SUNDRY NOTICES AND REPORTS ON WELLS
Do not use this form for proposals to drill or to re-enter an abandoned well. Use Form 3160-3 (APD) for such proposals.

ConocoPhillips Company respectfully request to amend the drill plan, directional plan, and bottom hole as indicated below and with the supporting documents attached.

PROSPECT/FIELD	Bonespring/Red Hills	COUNTY/STATE				Lea County, NM
OWNERS	ConocoPhillips	LEASE				
WELL NO.	Wildier Federal AC COM 28 #3H	FNL	FSL	FEL	FWL	
LOCATION		Surface Location:	224		1544	
		Bottom Hole Location:		330	1544	
EST. T.D.	Leg #1 16,190' MD	GROUND ELEV.			3,168' (est)	3,193' (est)

**PECOS DISTRICT
CONDITIONS OF APPROVAL**

Attachment # 2 Choke Manifold Configuration

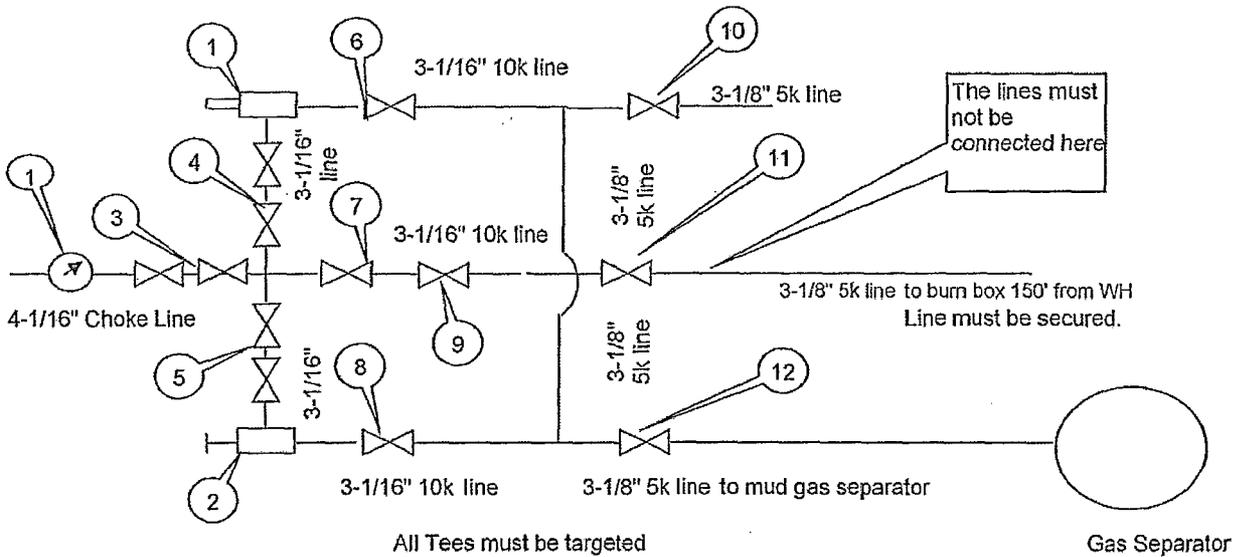
We will test each valve to 5000 psi from the upstream side.

2. Variance approved to use flex line from BOP to choke manifold. Check condition of flexible line from BOP to choke manifold, replace if exterior is damaged or if line fails test. Line to be as straight as possible with no hard bends and is to be anchored according to Manufacturer's requirements. The flexible hose can be exchanged with a hose of equal size and equal or greater pressure rating. **Anchor requirements, specification sheet and hydrostatic pressure test certification matching the hose in service, to be onsite for review.** If the BLM inspector questions the straightness of the hose, a BLM engineer will be contacted and will review in the field or via picture supplied by inspector to determine if changes are required (operator shall expect delays if this occurs).

Attachment # 3 BOP Stack Configuration

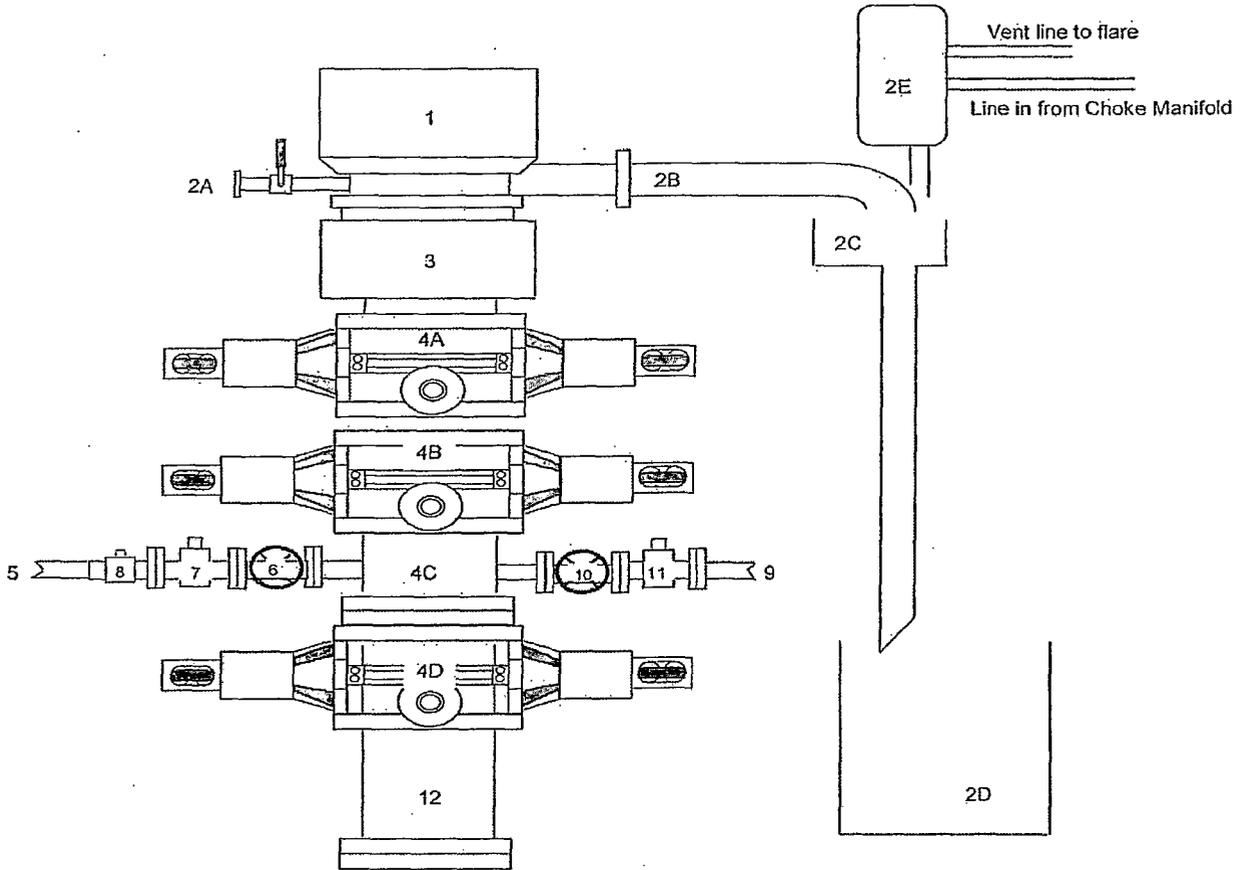
1. A different rig will be drilling this project than was permitted for. Please see attached BOP schematic
2. The setting depth of the 13 3/8" surface casing is proposed at ~~960'~~ **850' See COA**
3. The setting depth of the 9 5/8" intermediate casing is proposed at 4560'
4. An additional string of casing (7" 29# P110 BTC) will be added with a proposed setting depth of 9606'
5. An uncemented 4 1/2" liner will be run from 9100-16190 MD
6. The planned KOP is 8710 MD
7. The proposed bottom hole is 355 FSL & 1714 FWL in Section 33-26S-32E, Federal Lease NM107393. A communitization agreement will be filed.

3. Minimum working pressure of the blowout preventer (BOP) and related equipment (BOPE) required for drilling below the surface casing shoe shall be **5000 (5M) psi.**
